RE: **Approval of Plans (REV 1)**
TDOT Gibson County Maintenance Building
1248 B Manufacturers Row
Trenton, TN 38382

TFM # 21267
Project # 2023-11-09-02
County: Gibson

Revision #1 Drawing Changes

FIRST FLOOR LIFE SAFETY PLAN

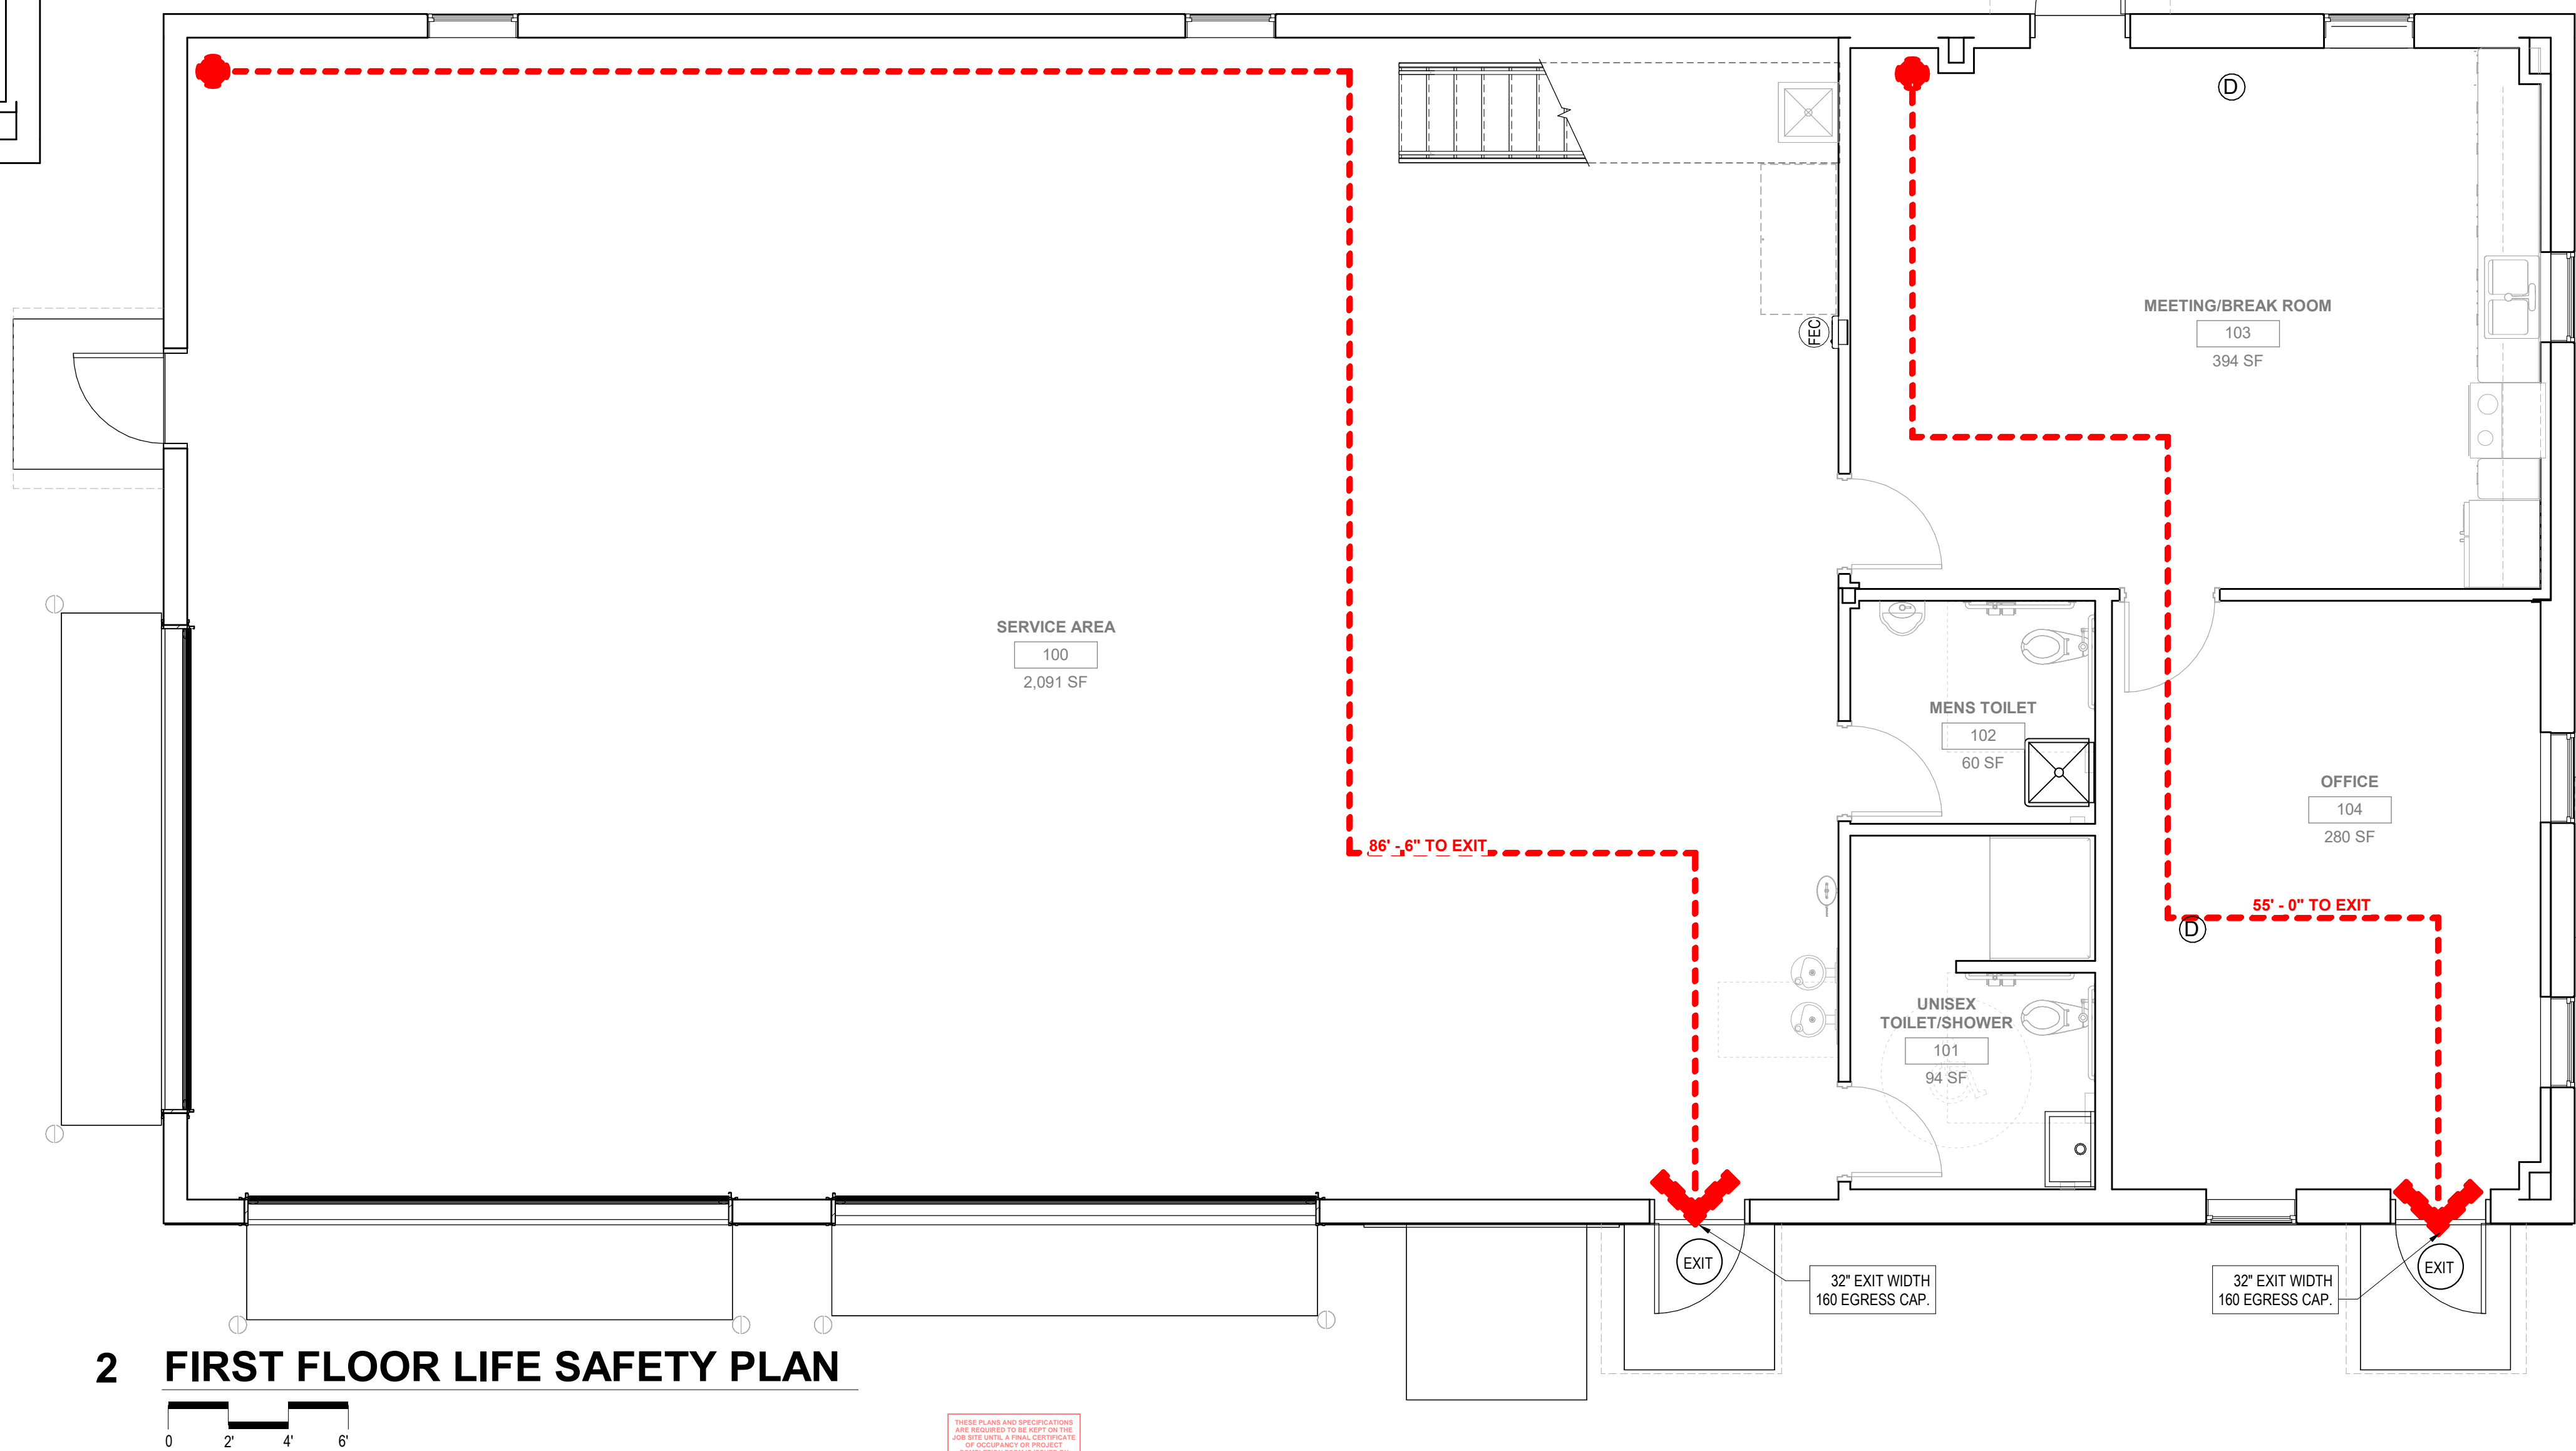
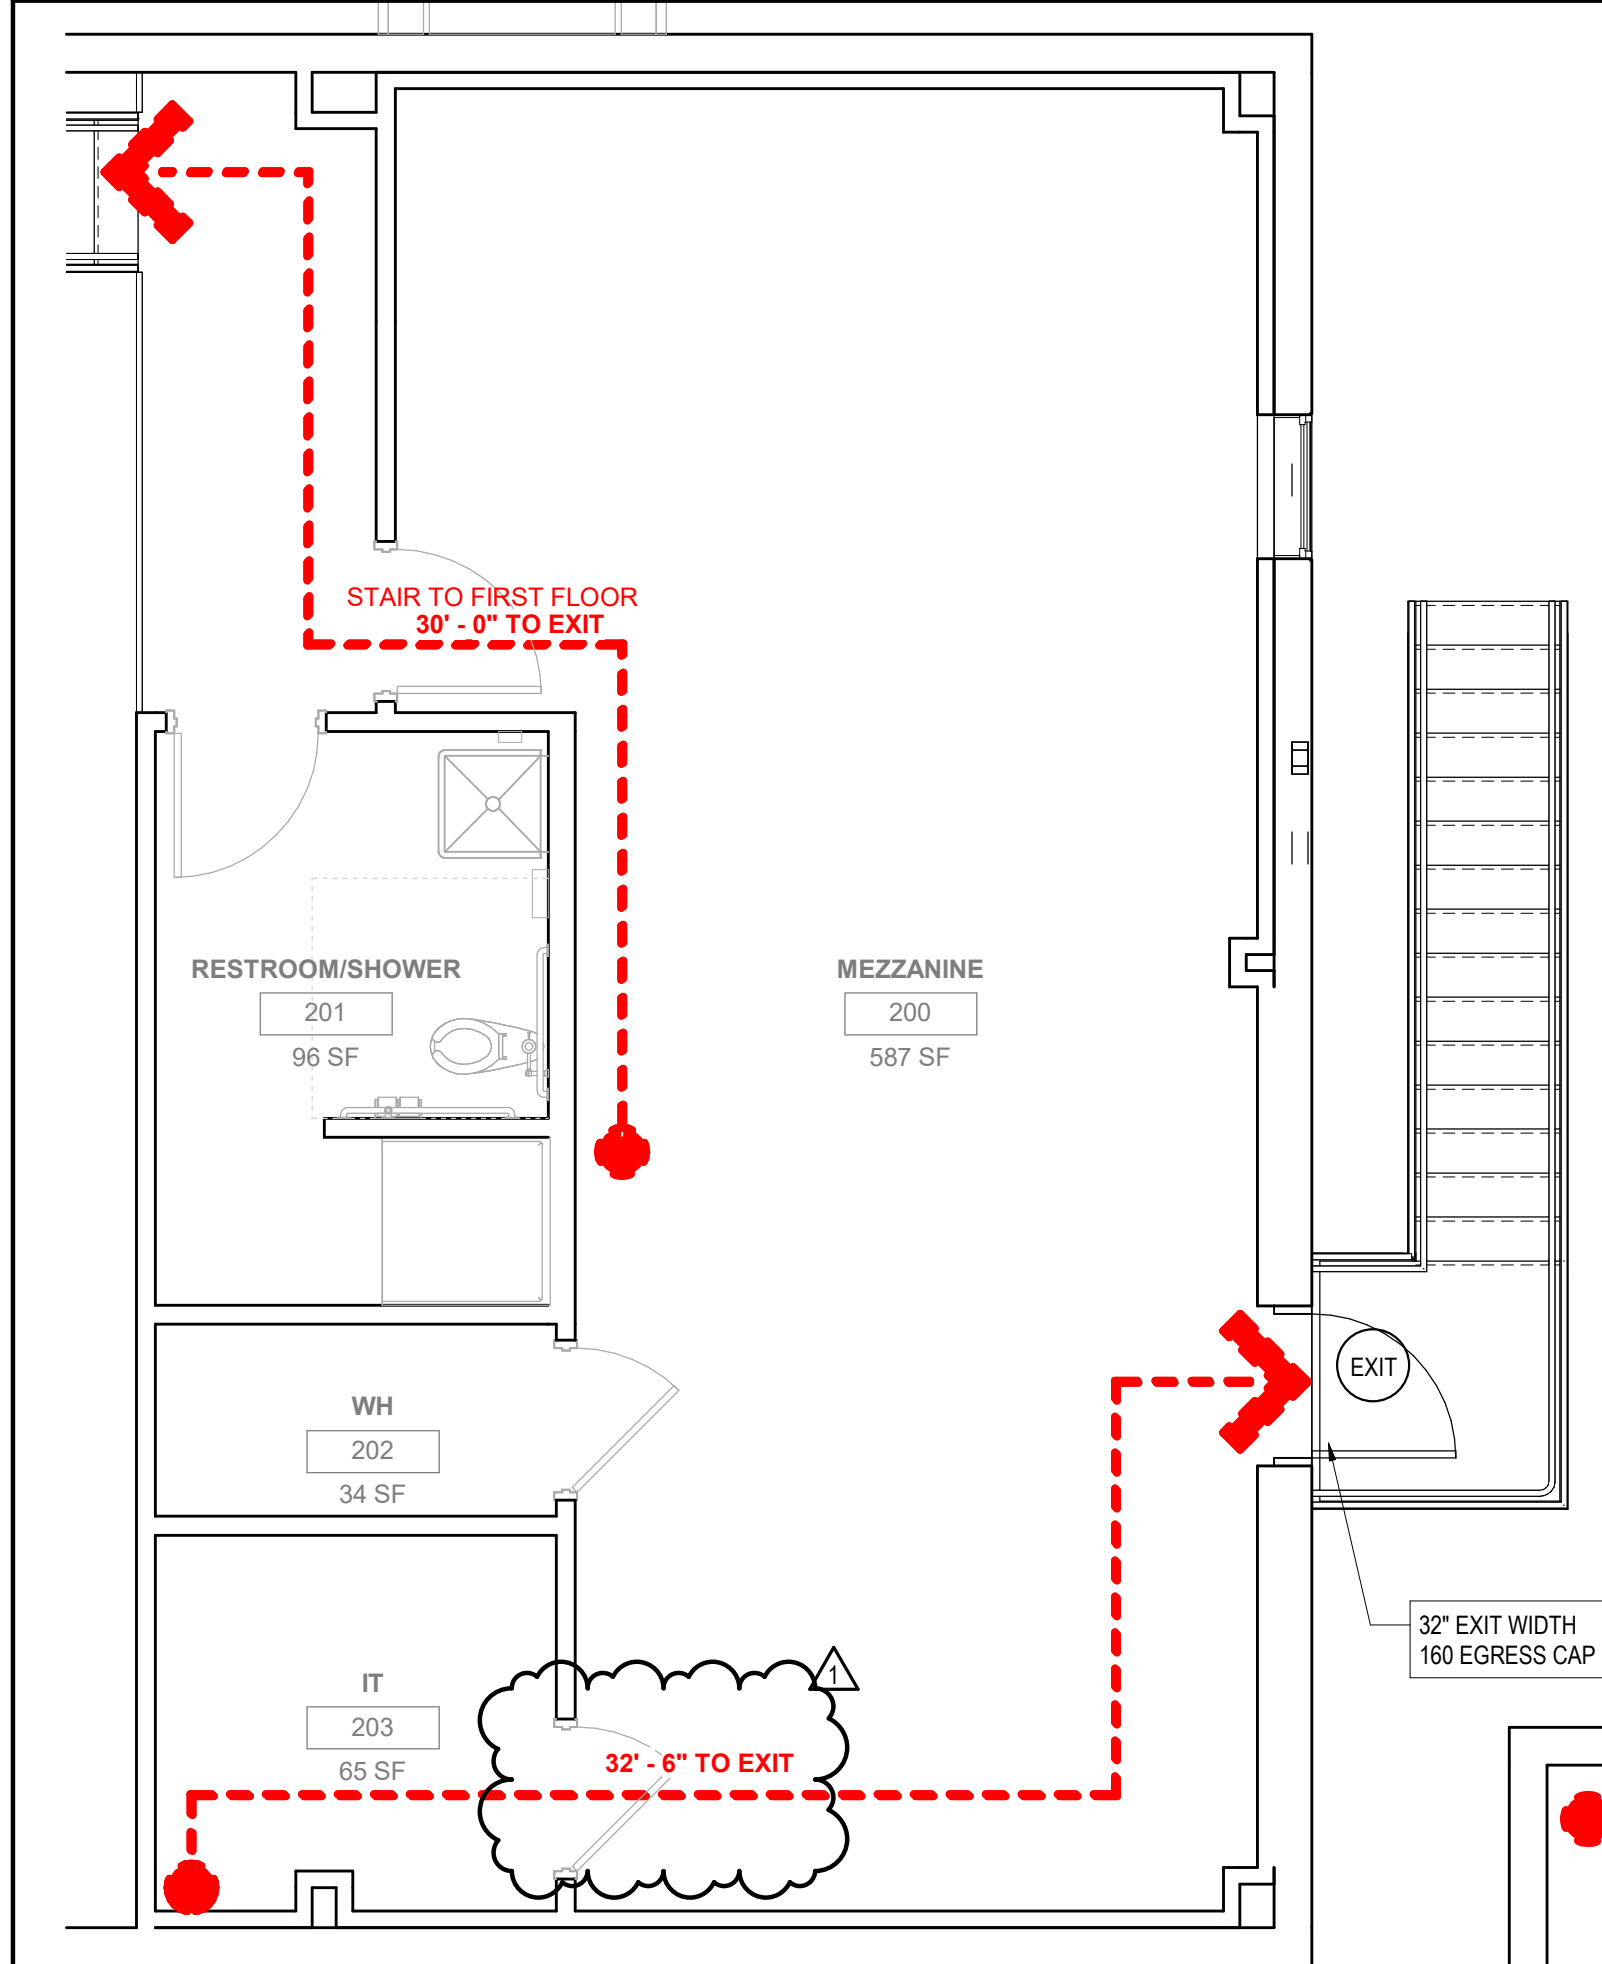
Sheet A09.01: Revised location of door to IT room.
